STAFF PAPER

Review of Vernon Public Utilities 2018 Integrated Resource Plan

July 2019 | CEC-200-2019-006

Figure 1: Vernon and Energy Commission Energy Demand Forecasts 2018–2030 (GWh)

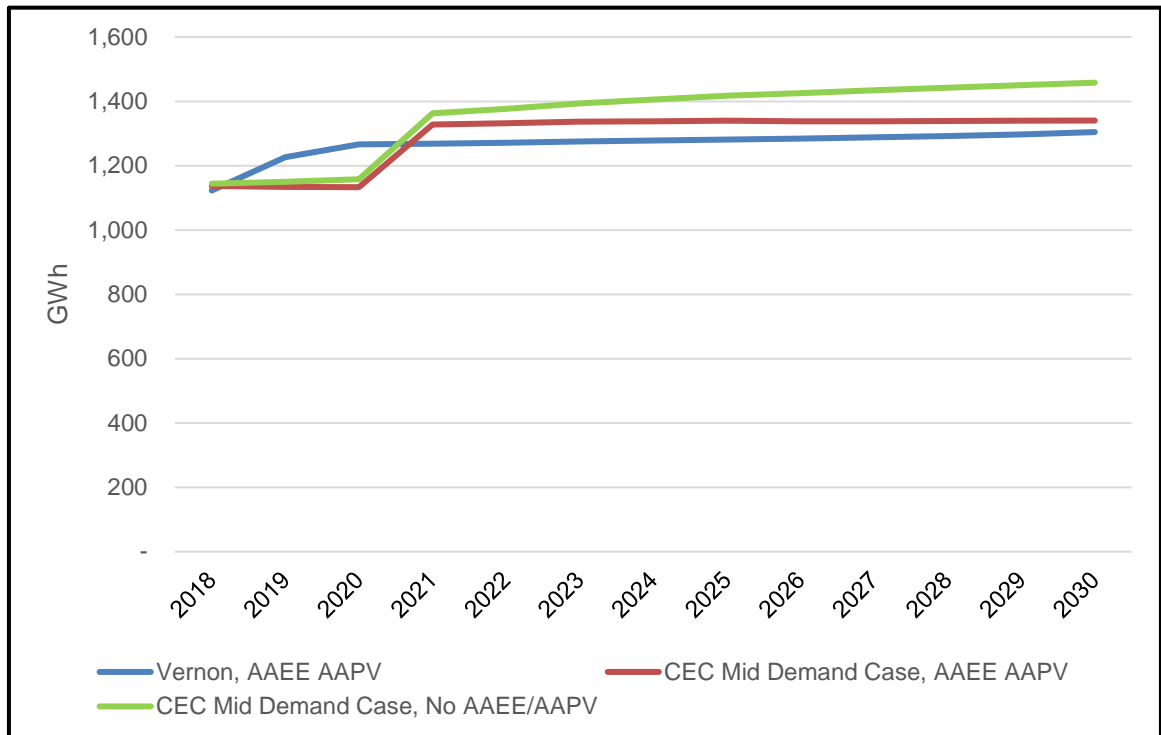
As shown in **Figure 1**, Vernon forecasts retail sales to increase 1.3 percent annually to 1,250 GWh in 2030. Forecasts through 2020 are higher than the Energy Commission’s forecast as Vernon anticipates large customer load additions in this period. By 2021, Vernon’s forecast follows the trend line of the Energy Commission’s demand forecast.

Figure 2: Vernon and Energy Commission Peak Forecasts 2018–2030 (MW)

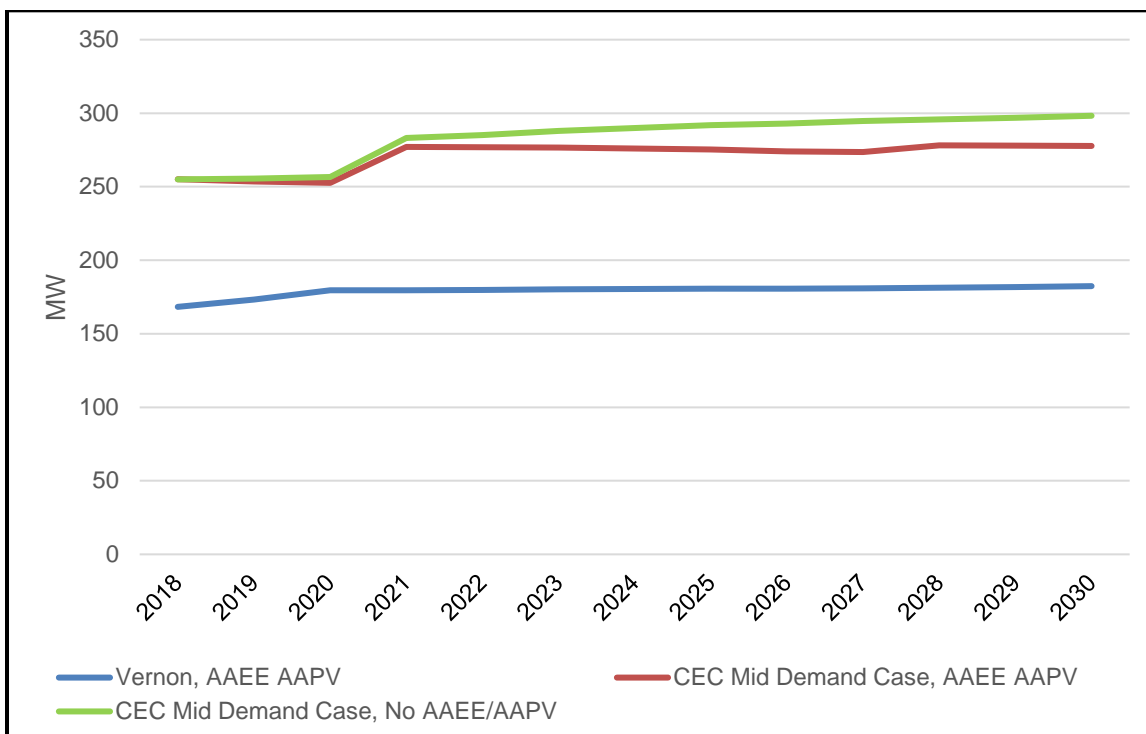
In **Figure 2**, Vernon forecasts a significantly lower peak demand in each year, by about 70 MW, compared to the Energy Commission. Vernon’s forecasts ranges from 199 MW in 2019 to 210 MW in 2030, while the Energy Commission’s forecast ranges from 255 MW in 2019 to 278 MW in 2030 (AAEE/AAPV). Differences between the models specifications, data, and assumptions can make it difficult to compare the long-term demand forecasts developed by Vernon to the Energy Commission’s forecasts.
